**From:** WILLIFORD Dennis (AREVA) [mailto:Dennis.Williford@areva.com]  
**Sent:** Friday, March 23, 2012 2:30 PM  
**To:** Tesfaye, Getachew  
**Cc:** BENNETT Kathy (AREVA); DELANO Karen (AREVA); ROMINE Judy (AREVA); RYAN Tom (AREVA); KOWALSKI David (AREVA)  
**Subject:** Response to U.S. EPR Design Certification Application RAI No. 461, FSAR Ch. 9, Supplement 9

The attached file, "RAI 461 Supplement 9 Response US EPR DC.pdf" provides a technically correct and complete final response to the remaining 3 questions (Questions 09.04.01-3, 09.04.03-4 and 09.04.03-6).

**QUESTIONS for Containment and Ventilation Branch 1 (AP1000/EPR Projects)  
(SPCV)**

Figure 2.6.5-1—Nuclear Auxiliary Building Exhaust Filtration Trains Subsystem Functional Arrangement

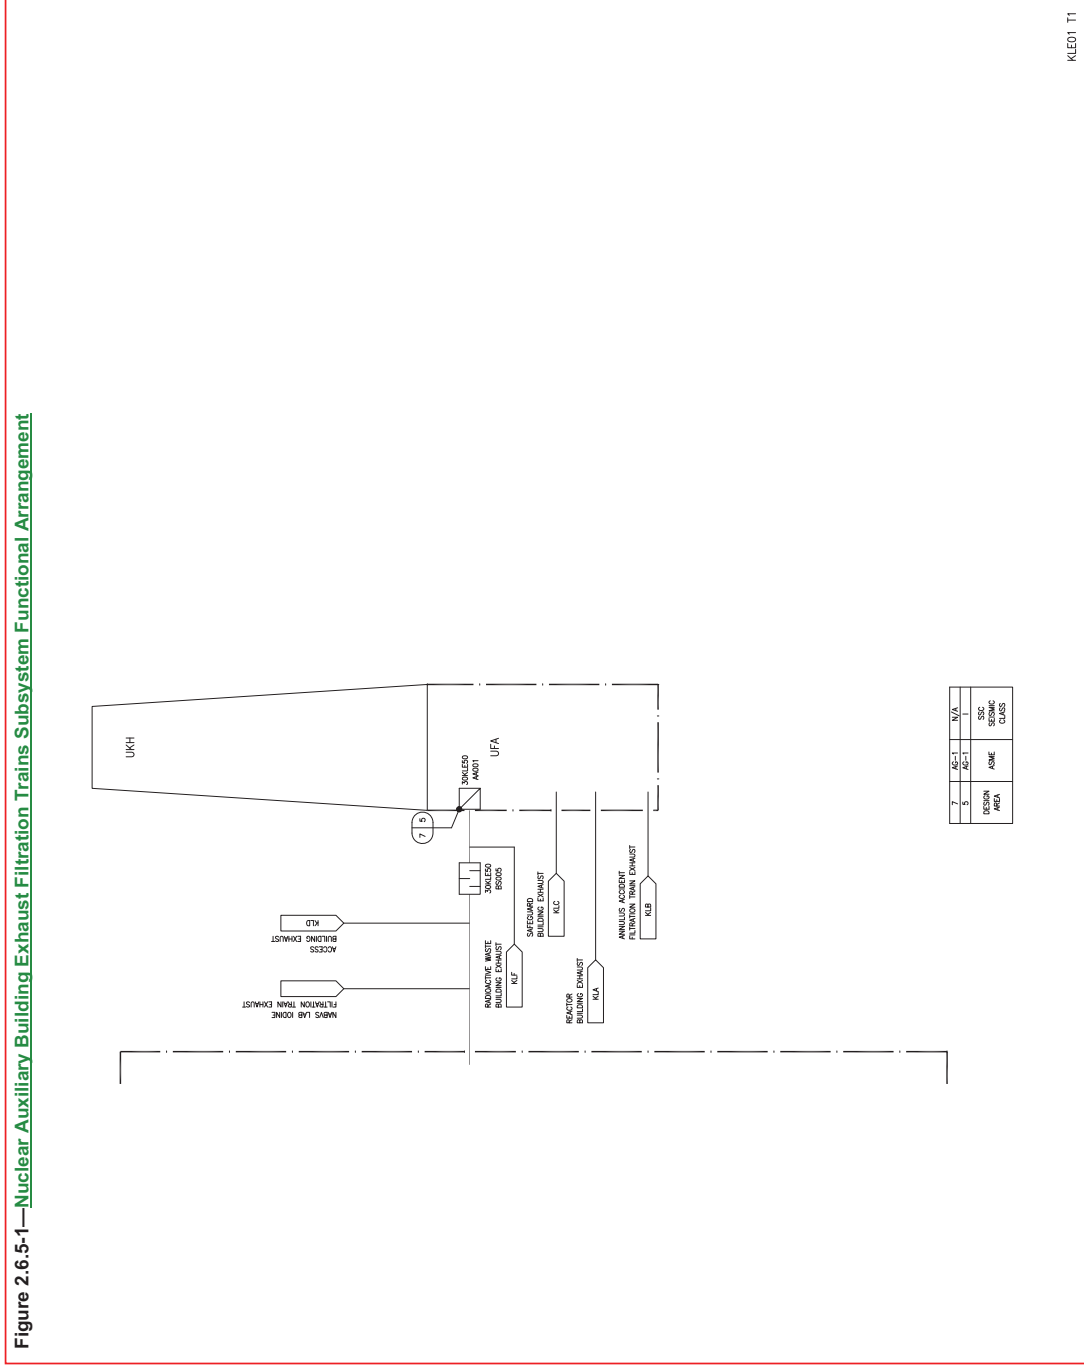
1. Clarify Figure 9.4.3-3 to indicate that the plant stack, which serves as the exhaust path of the FBVS, is SSC seismic Class 1 and SSC Quality Group B, and a safety-related portion of the system.
2. Clarify the Seismic and Quality Classification breaks for the vent stack as they are shown in the FSAR in the same manner for the following Systems/ P&IDs:
  - a. Safeguard Building Controlled-Area Ventilation System Figure 9.4.5-2
  - b. Radioactive Waste Exhaust/ Figure 9.4.8-2
  - c. Reactor Building Exhaust/ Figure 9.4.7-2
  - d. Annulus Accident Filtration Train Exhaust/ Figure 6.2.3-2

To support the change in the safety and seismic classification of the backdraft damper in the discharge of the NABVS exhaust to the plant vent stack, a new U.S. EPR FSAR Tier 1, Section 2.6.5 has been created. This includes new U.S. EPR FSAR Tier 1, Tables 2.6.5-1—Nuclear Auxiliary Building Ventilation System Equipment Mechanical Design, and 2.6.5-2—Nuclear Auxiliary Building Ventilation System ITAAC, and a new U.S. EPR FSAR Tier 1, Figure 2.6.5-1—Nuclear Auxiliary Building Exhaust Filtration Trains Subsystem Functional Arrangement.

2.1 The functional arrangement of the NABVS exhaust backdraft damper at the vent stack is as shown on Figure 2.6.5-1—Nuclear Auxiliary Building Exhaust Filtration Trains Subsystem Functional Arrangement.

Figure 9.4.14-2—Access Building Ventilation System – Supply and Exhaust Air Subsystem

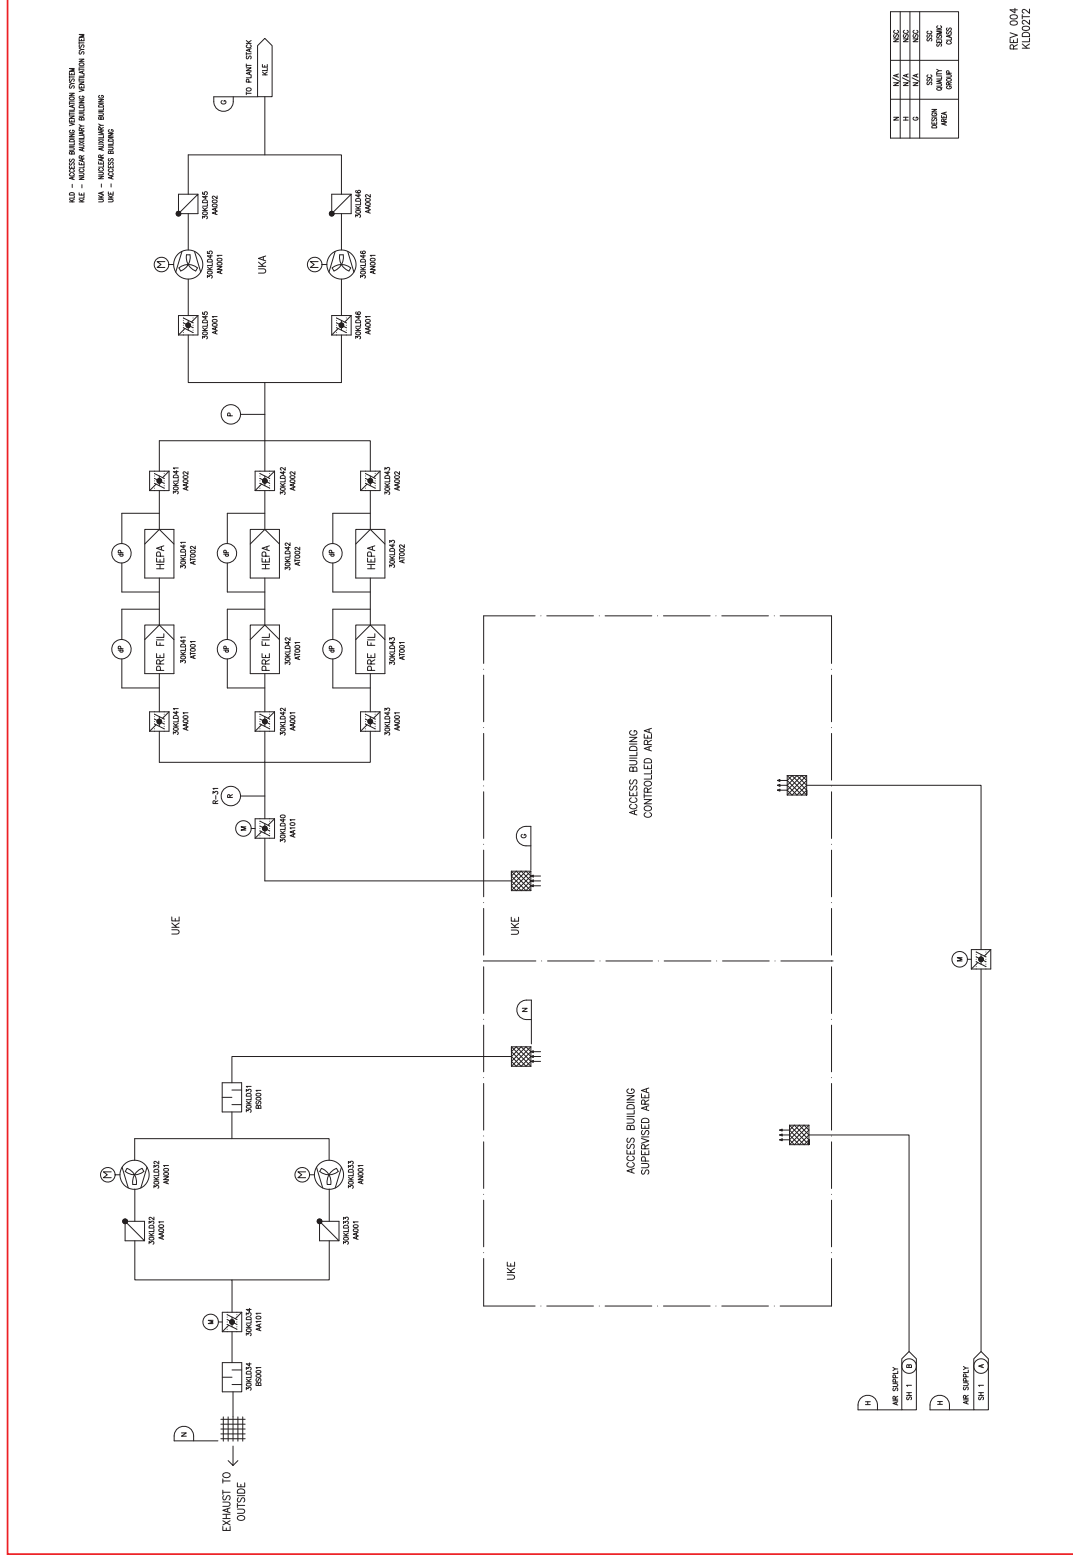
The Tier 2 FSAR section 9.4.14 and Figure 9.4.14-2 describes the Access Building Ventilation System as servicing an Access Building that is divided into a radiological controlled area, which presumably has the potential to become contaminated. Both the controlled area of this building and a supervisory area are serviced by the ABVS. The ABVS as shown in the FSAR has two different exhaust subsystems. The subsystem that services the controlled areas exhausts through HEPA filters and is monitored for radioactivity. The exhaust subsystem that services the supervisory area releases directly to the environment with no devices to filter radioactivity or monitor for radioactivity. Based on the review of this system the staff requests the following information:

1. Provide justification for not subjecting the Supervisory area of the Access Building to GDC 60. i.e., provide the location in the FSAR for the description of the controls that separate the contaminated areas from clean areas in the Access Building.

- b. The description should specifically address the ABVS functions in the event of an indication, via plant stack radiation monitor or other means, of radioactive contamination downstream of the ABVS HEPA filtration units.

1. U.S. EPR FSAR Tier 2, Sections 9.4.14.1 and 9.4.14.4, state that the access building ventilation system (ABVS) is subject to the requirements of GDC 60.
  - a. The controlled areas of the Access Building are maintained at a negative pressure, while the supervised areas adjacent to the controlled areas, are maintained at ambient pressure. Clean air from the supervised areas will flow to potentially contaminated controlled areas and will then be filtered by a HEPA filtration unit and be exhausted to the plant vent stack. The system design configuration maintains air flow from clean areas to potentially contaminated

U.S. EPR FSAR Tier 2, Figure 9.4.14-2, "Access Building Ventilation System - Supply and Exhaust Air Subsystem," will be revised to include this clarifying information.

U.S. EPR FSAR Tier 2, Sections 9.4.14.1, 9.4.14.2.1, 9.4.14.3.1 and 9.4.14.4, and Figure 9.4.14-2, will be revised as described in the response and indicated on the enclosed markup.

Figure 9.4.3-3—Nuclear Auxiliary Building Exhaust Filtration Trains Subsystem

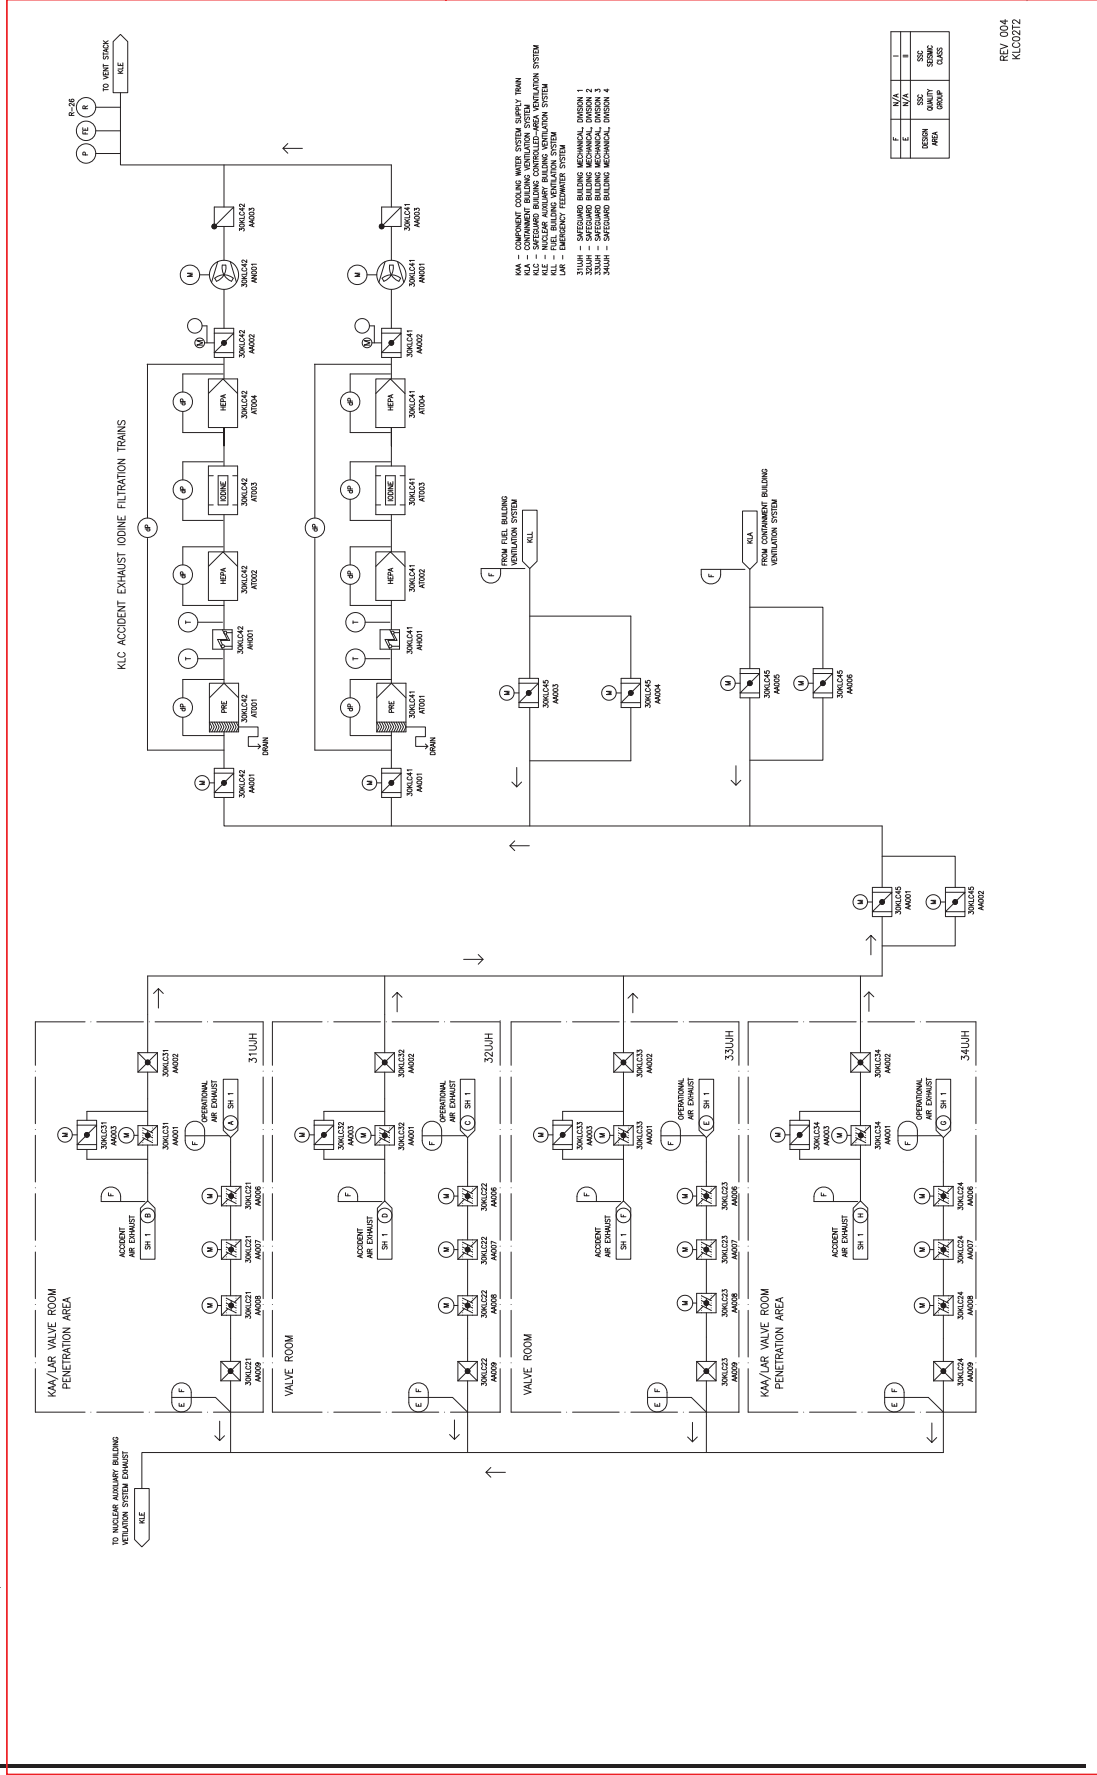
A review of Figure 9.4.3-3 apparently shows the FB and vent stack as non seismic and non safety related structures. This conflicts with Table 3.2.2.1-1 for those structures. Since the plant stack is used by safety related ventilation systems such as the AVS, this structure should be correctly designated on this figure as safety-related and Seismic Category 1. Since the vent stack is part of the AVS, which is relied upon to establish a negative pressure in the annulus and fission product removal after a design basis accident, the Quality group for the vent stack should be Quality Group B.

1. The safety and seismic classification of the plant vent stack have been upgraded to safety-related, Seismic Category I. This change reflects the installation of a safety-related backdraft damper in the discharge of the nuclear auxiliary building ventilation system (NABVS) exhaust to the vent stack. This backdraft damper will close during accident conditions to isolate the non-safety-related portions of the NABVS from the safety-related plant vent stack. The quality group for the heating, ventilation and air conditioning (HVAC) ducting will be shown as N/A, per the guidelines of RG 1.26.

U.S. EPR FSAR Tier 2, Figure 9.4.3-3—Nuclear Auxiliary Building Exhaust Filtration Trains Subsystem will be revised to reflect the change in safety and seismic classification of the backdraft damper located in the NABVS exhaust at the plant vent stack.
